DRAWINGS BY *George Pereira*
APRIL 20, 1983

OSPREY 2 NEWSLETTER
35079 Road J
Oconomowoc, WI 53066

SEE DWG. NO. 33

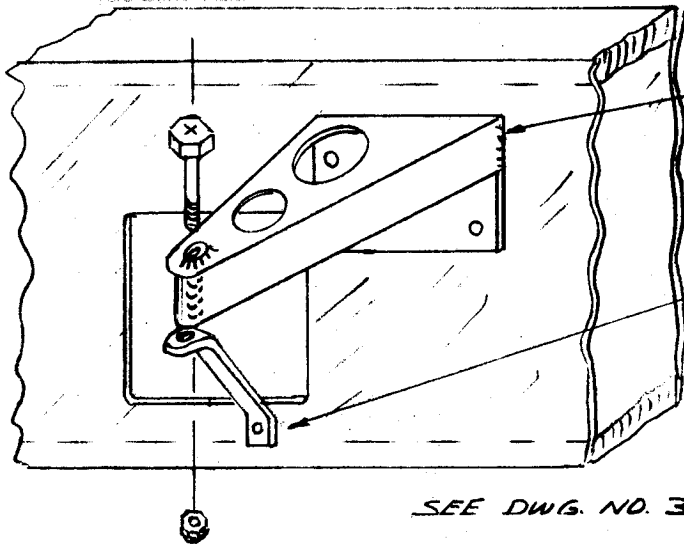
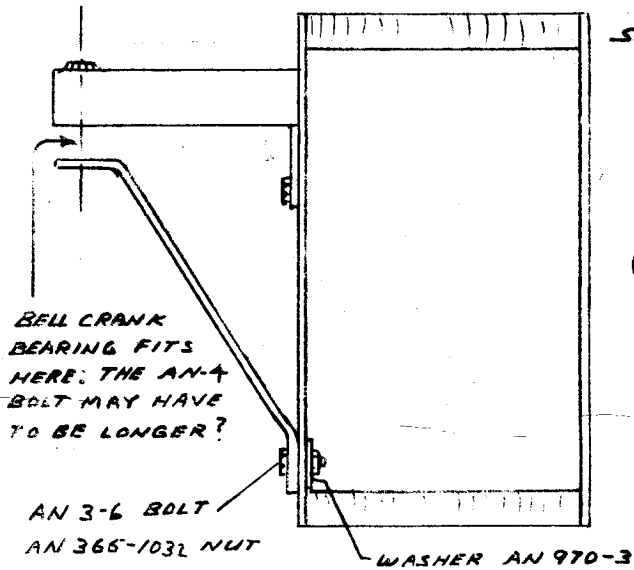
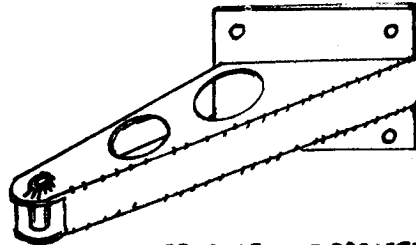
A couple of builders have mentioned that the aileron bracket shown on drawing No. 33 has a tendency to flex up and down when a heavy aileron load is applied. This could possibly cause the bracket to fail in the welded area if flexing continues. A simple fix to this potential problem is to attach a simple brace from the underside of the bellcrank bearing down to the spar web. (See enclosed drawing) A problem of retrofitting this brace is drilling the 3/16" hole in the web working through the inspection hole. If you don't have a close right angle drill you can sharpen a round 3/16 dia. rod, heat it and burn a neat hole through the web using the brace hold as a guide. I recommend all builders to look into this if your Osprey is finished or install the brace while building this portion of your control assembly. The Derrick built bracket now has a set of bolts top and bottom on the mount flange and will probably negate any need for the brace. Derrick made a change in this bracket about two years ago. If you have his later bracket the mount flange will be different than the drawing. The mounting holes are above and below the welded bracket. If you have the older bracket use the brace.

BRACE PREVENTS
POSSIBLE WELD
FISSURE HERE:

BELL CRANK
BEARING FITS
HERE: THE AN-4
BOLT MAY HAVE
TO BE LONGER?

TO DRILL WEB
USE NOT 3/16
DIA. ROD TO BURN
HOLE IF YOU DONT
HAVE CLOSE IN
RT. ANGLE DRILL
MOTOR

AN 3-6 BOLT
AN 365-1032 NUT

WASHER AN 970-3

REDESIGNED BRACKET
NOW FURNISHED BY
DERICK

.125 THK. ALUM. BRACE: LENGTH TO FIT
